# 7-ELEVEN

STORE #38421

STATE HIGHWAY NO. 66 & WILLOW BEND  
ROCKWALL, TEXAS 75087

"RECORD DRAWINGS"  
These drawings have been revised to show changes during the construction process reported by the contractor to Evolving Texas and considered significant. This drawing is not guaranteed to be "As Built", but is based on visual inspection and the information available and provided to Evolving Texas  
Date: 10/9/2019 By: *Samantha D. Renz*

DRAINAGE NOTE:  
- FOR THE OIL/WATER SEPARATOR SEE THE STORMCEPTOR DETAIL ON SHEET 23.

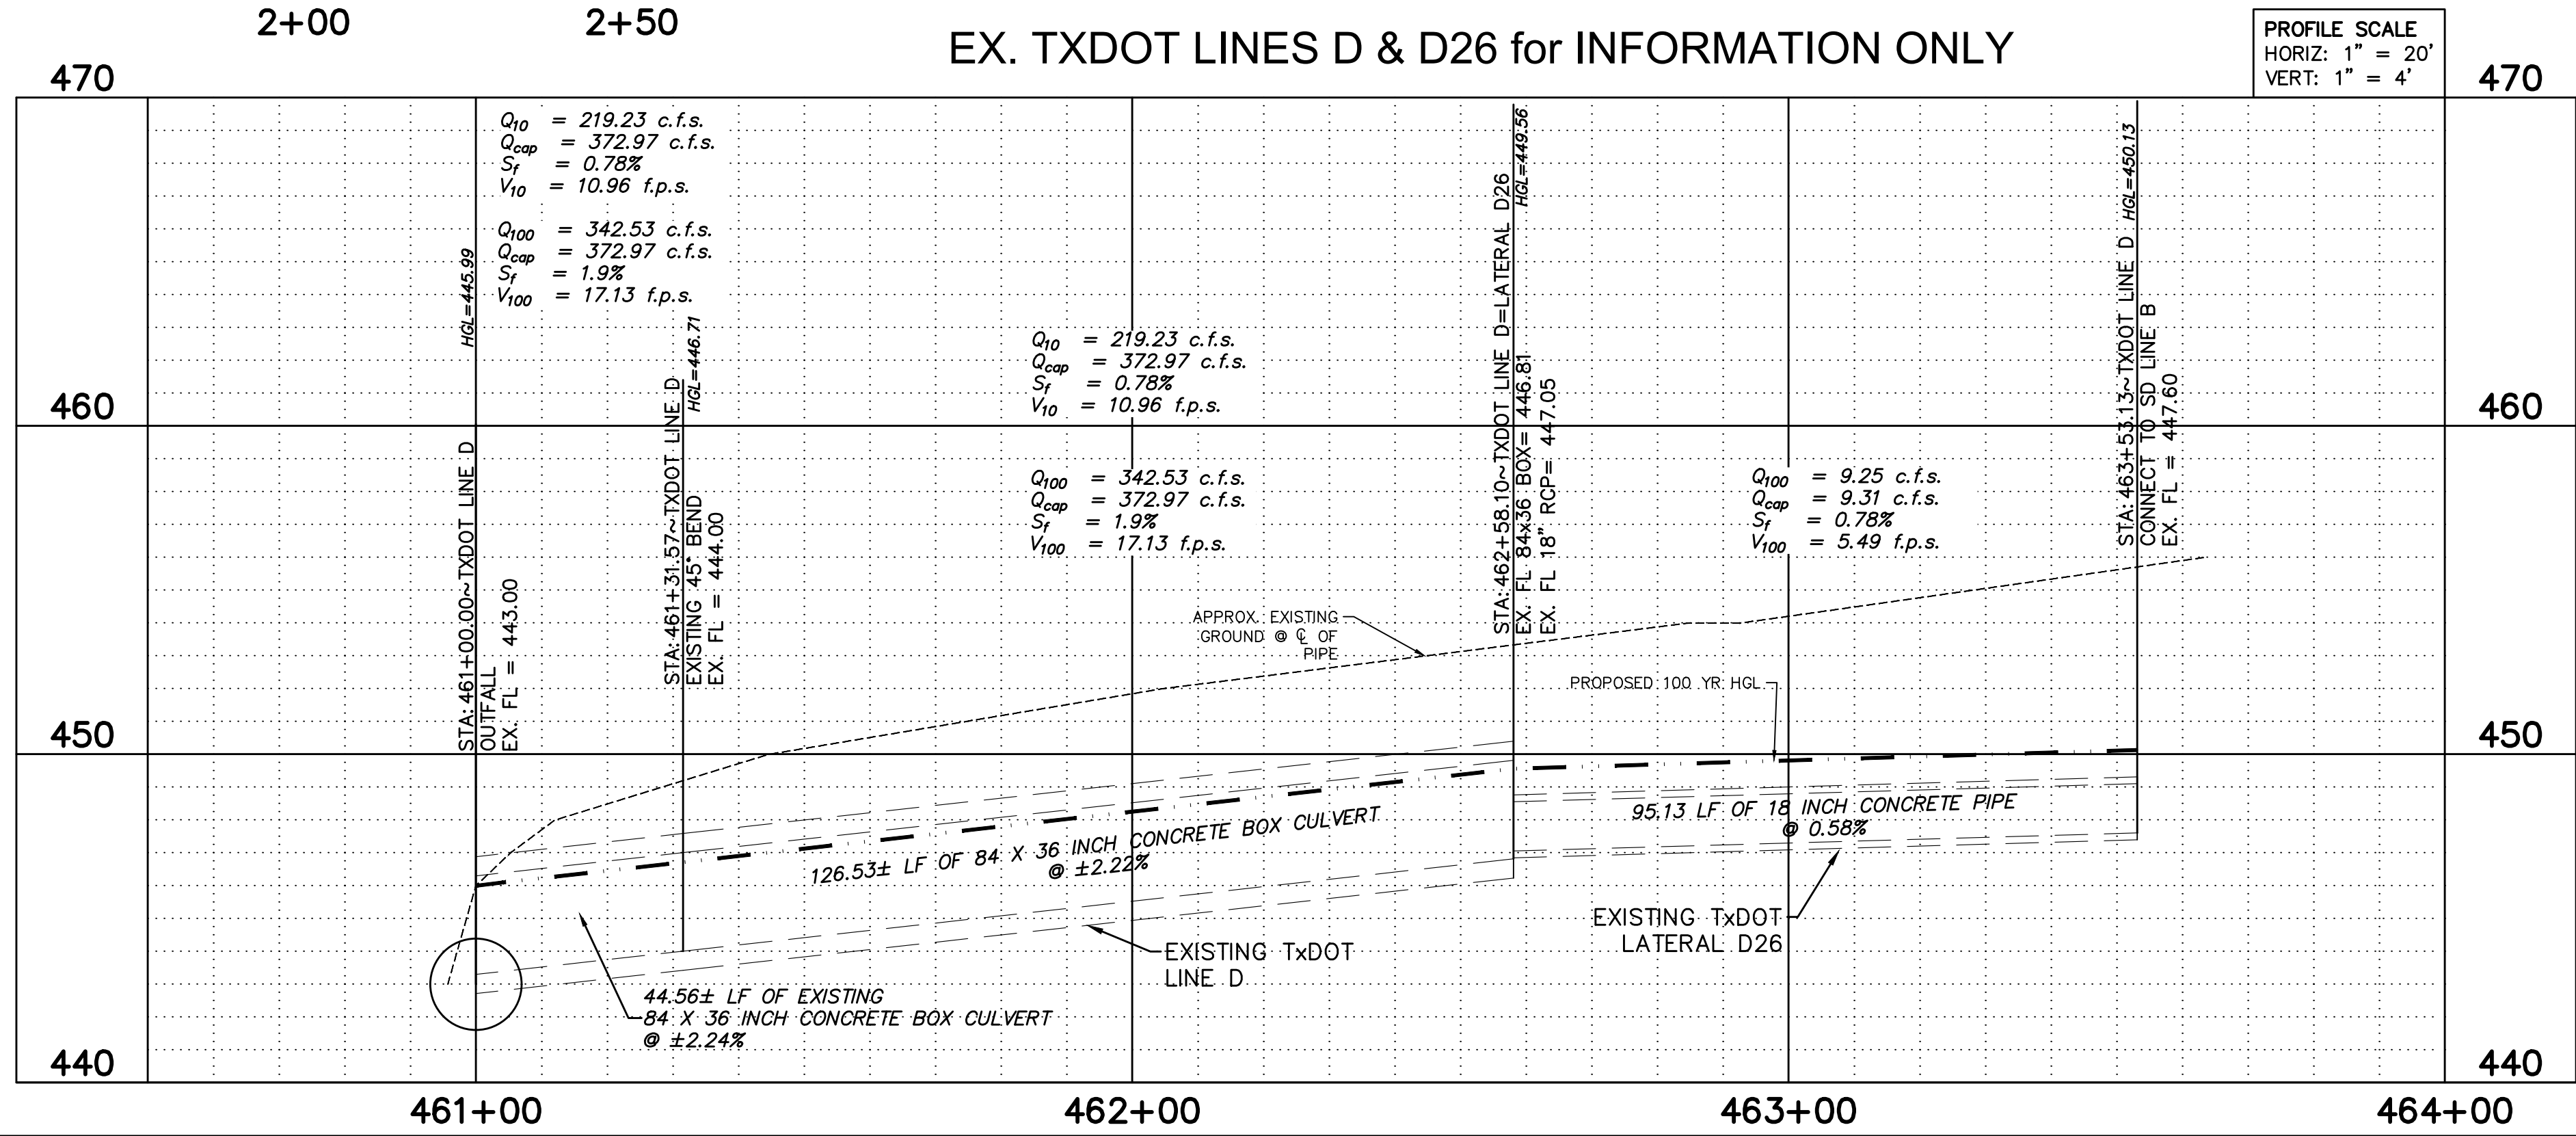
NO.	DATE	COMMENTS
1	1/21/19	Revised box culvert size to 4'x4' & HGL
2	2/1/19	Revised box culvert size from 4'x4' to 4'x5' & HGL

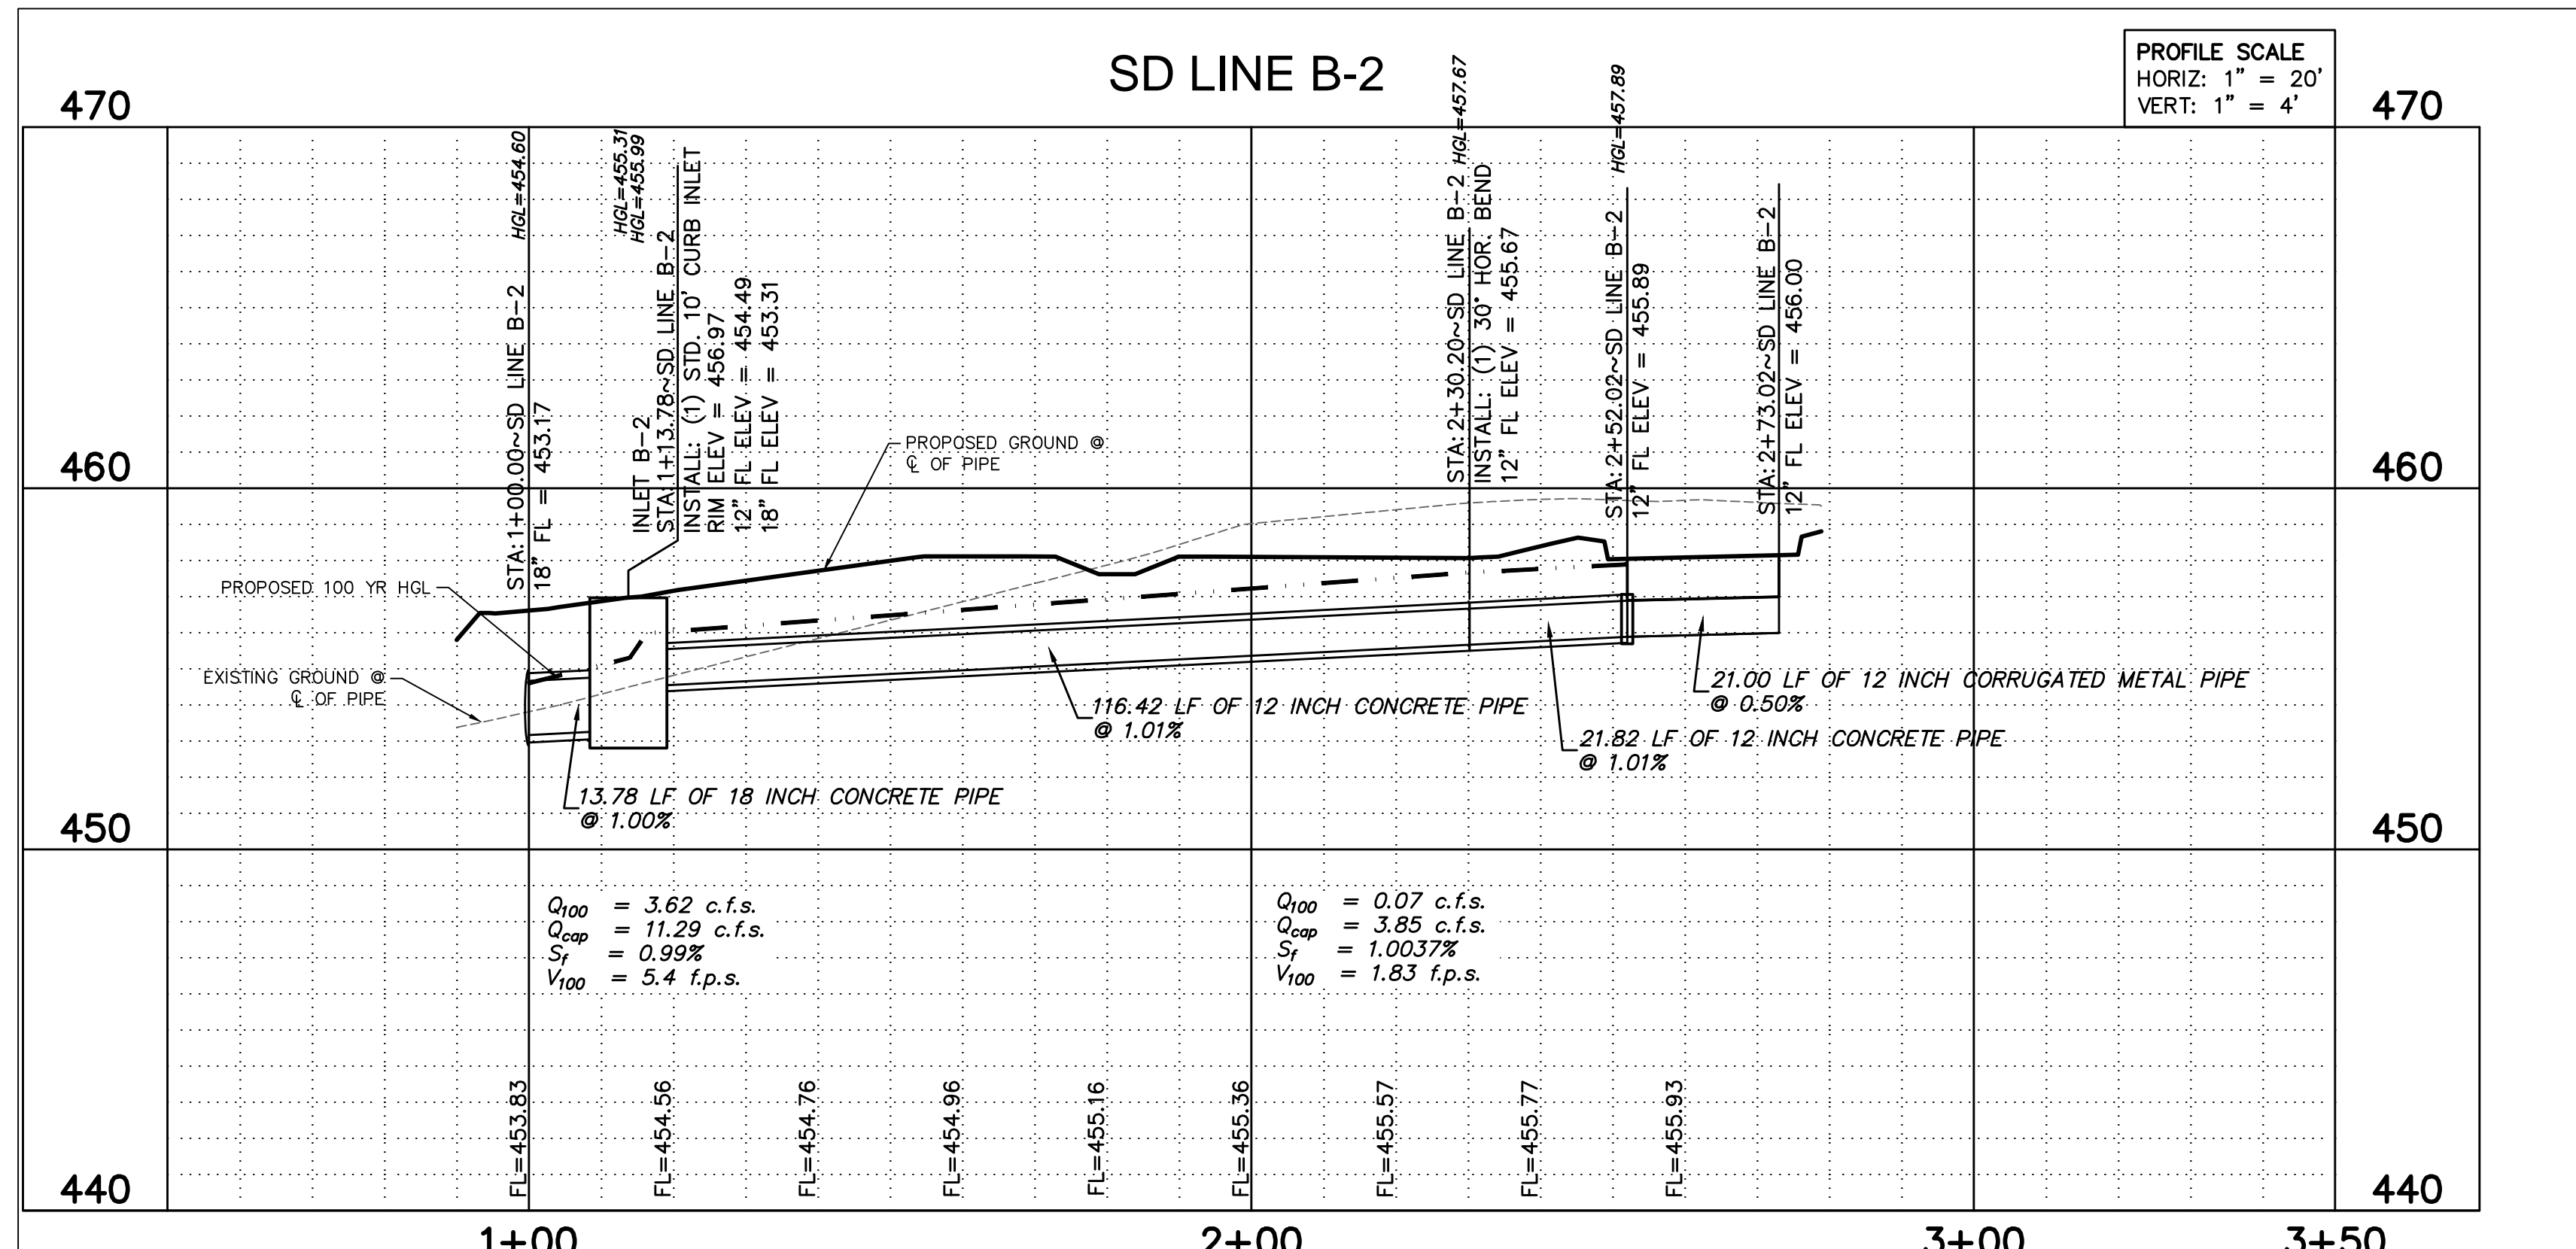
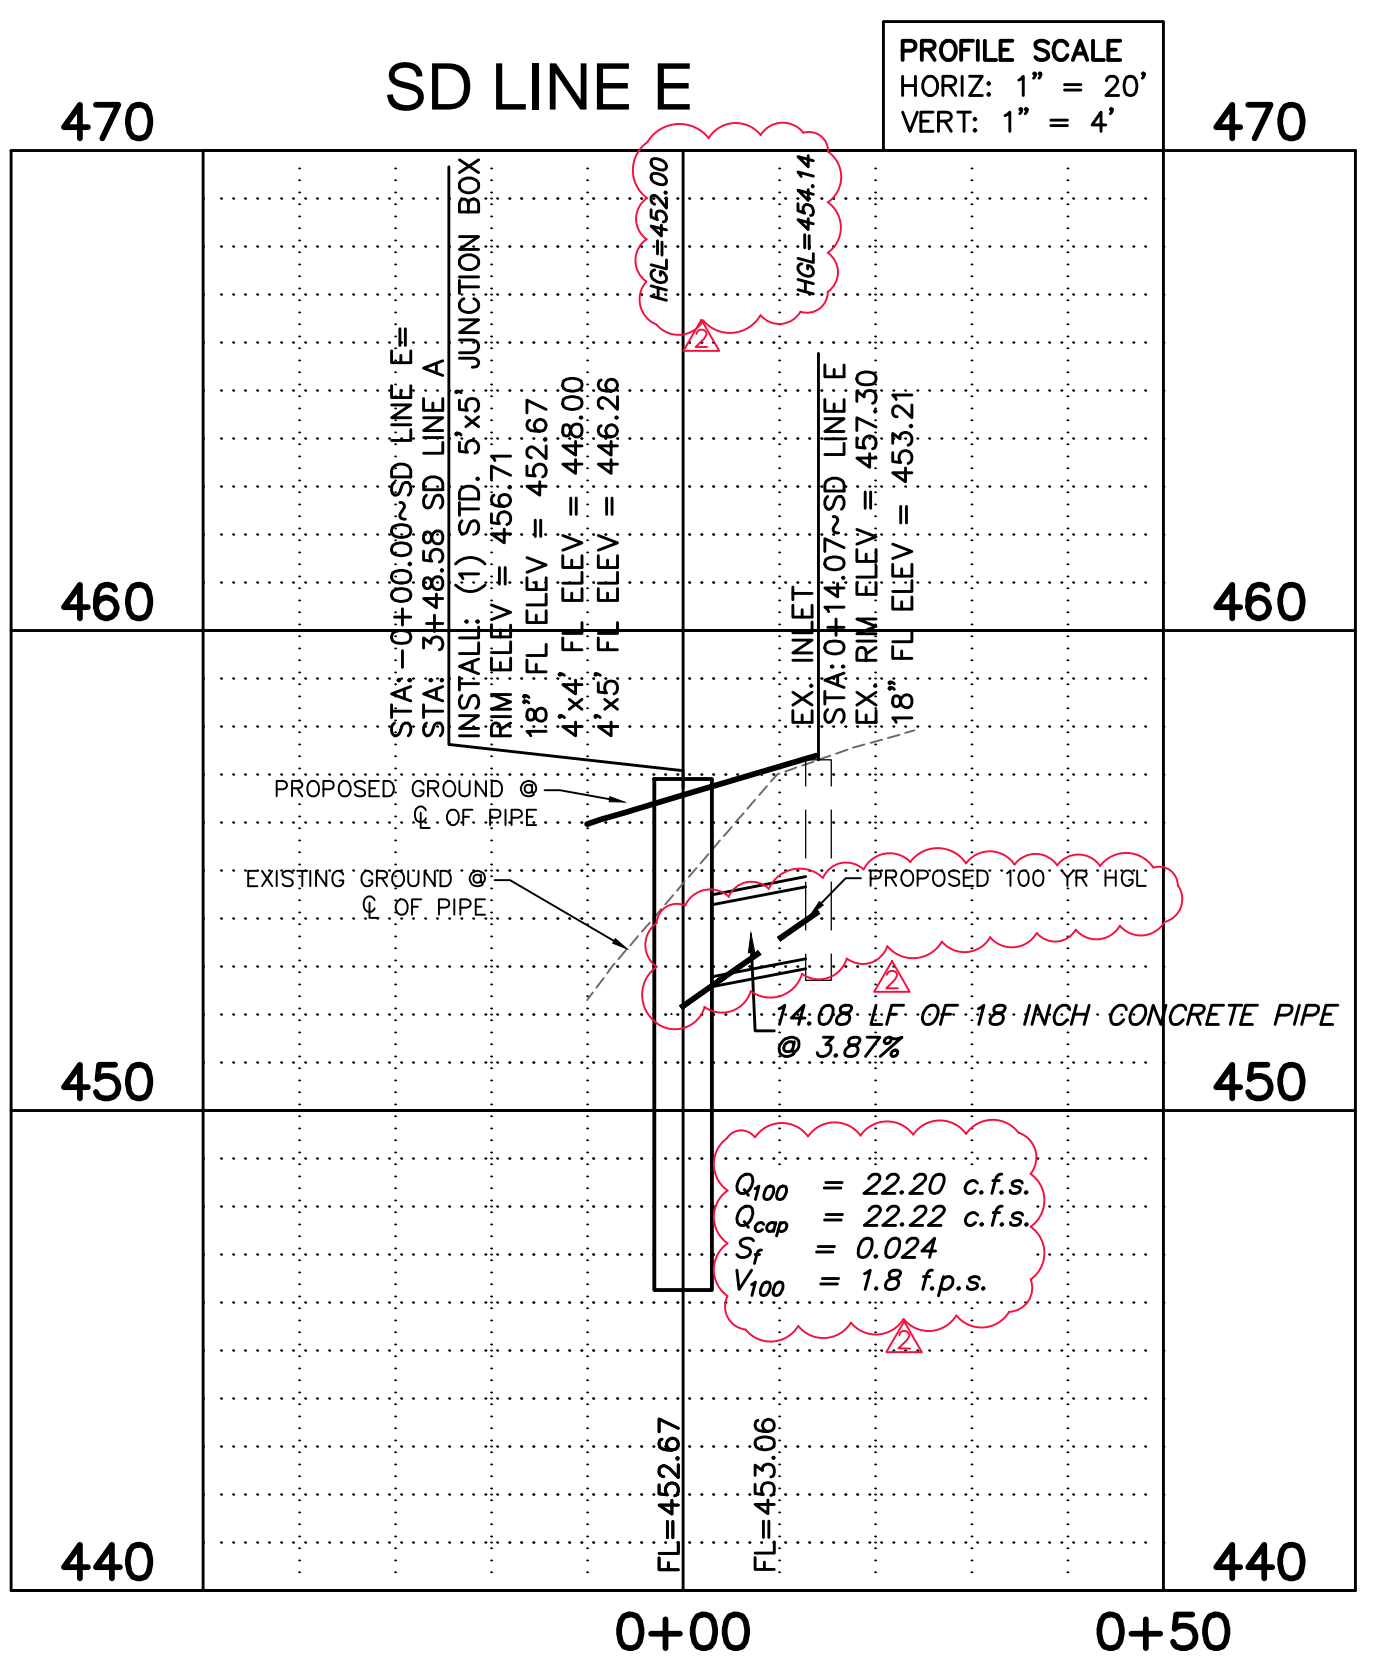
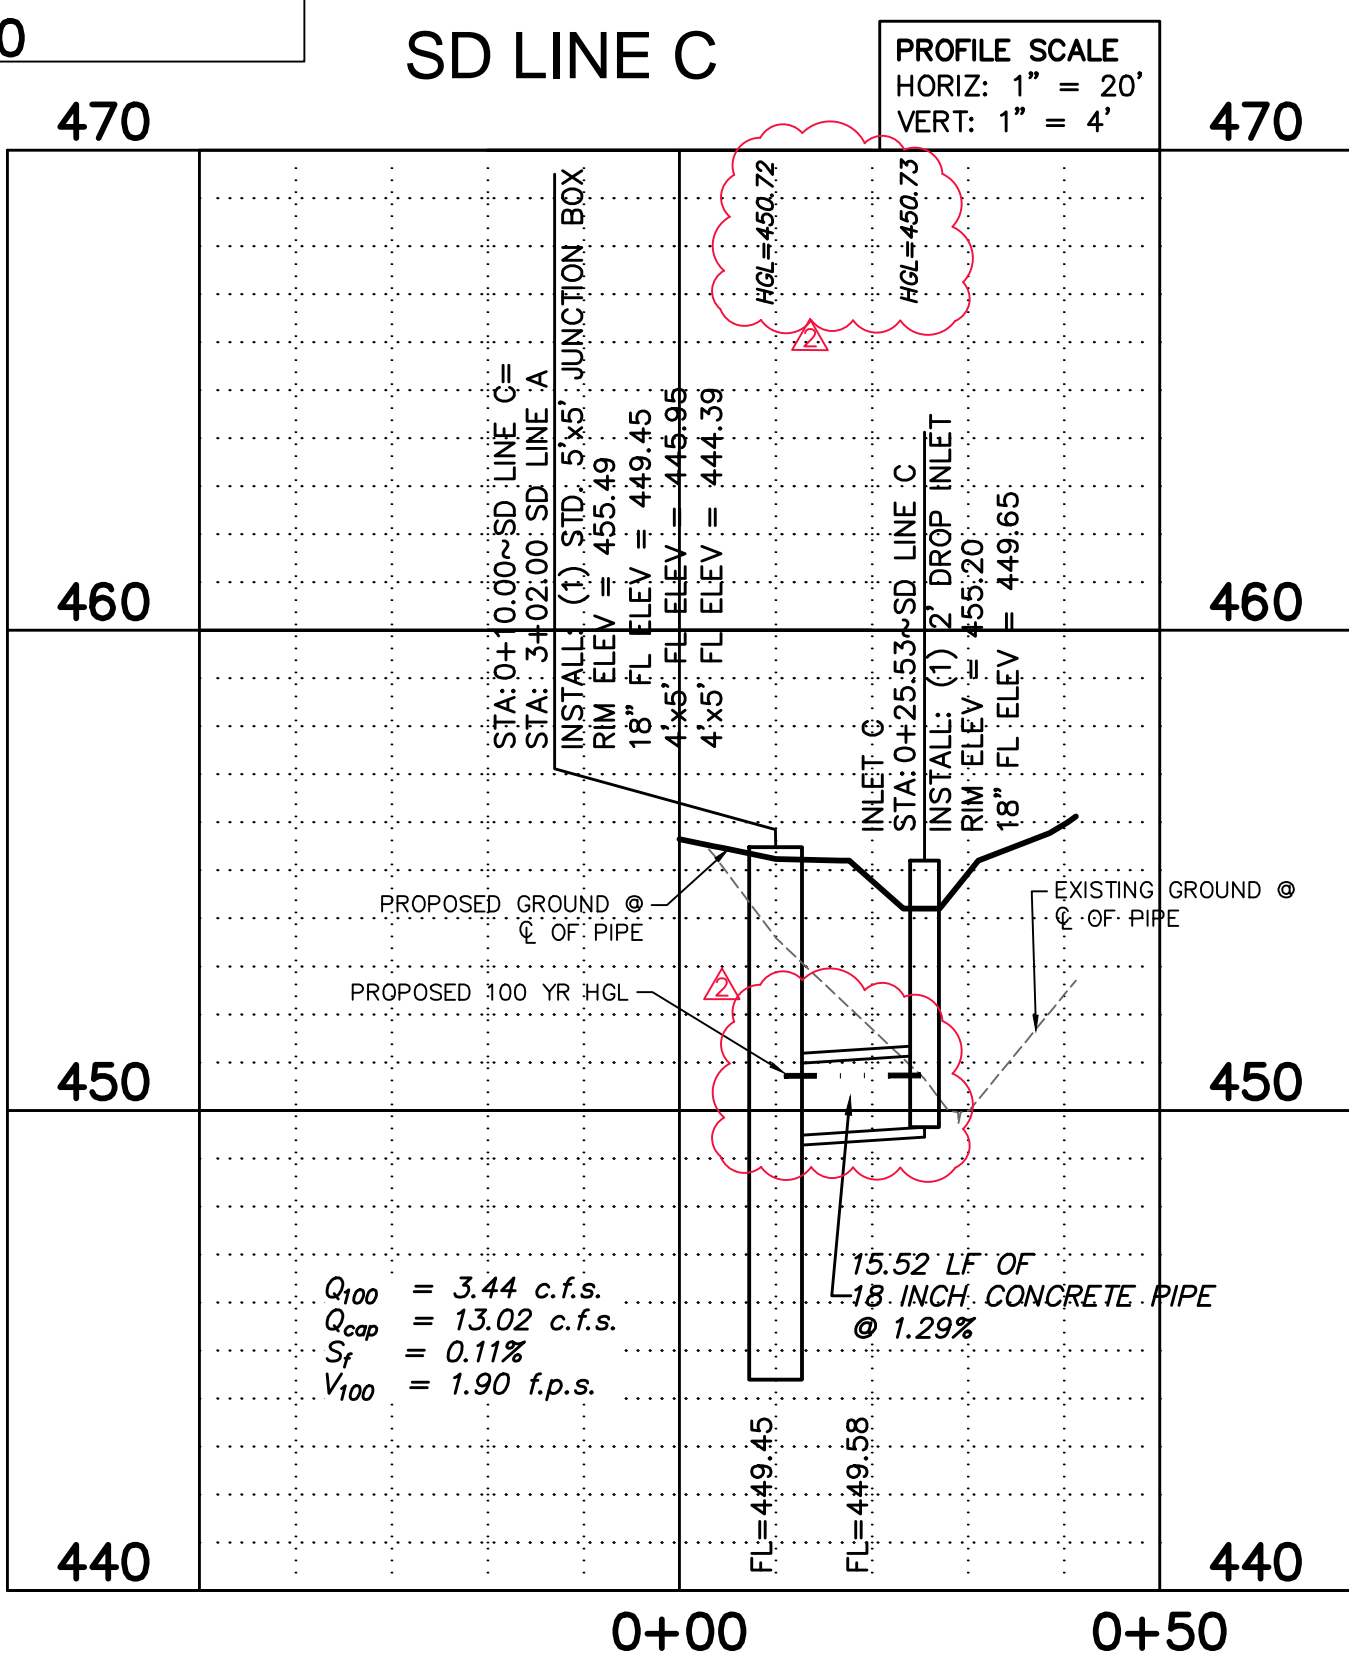
NO.	DATE	COMMENTS
1	1/21/19	Revised slotted drain alignment, P. format of computer enclosure due to shift
2	2/7/19	Revised box culvert size from 4x4' to 4x5' and HGLs
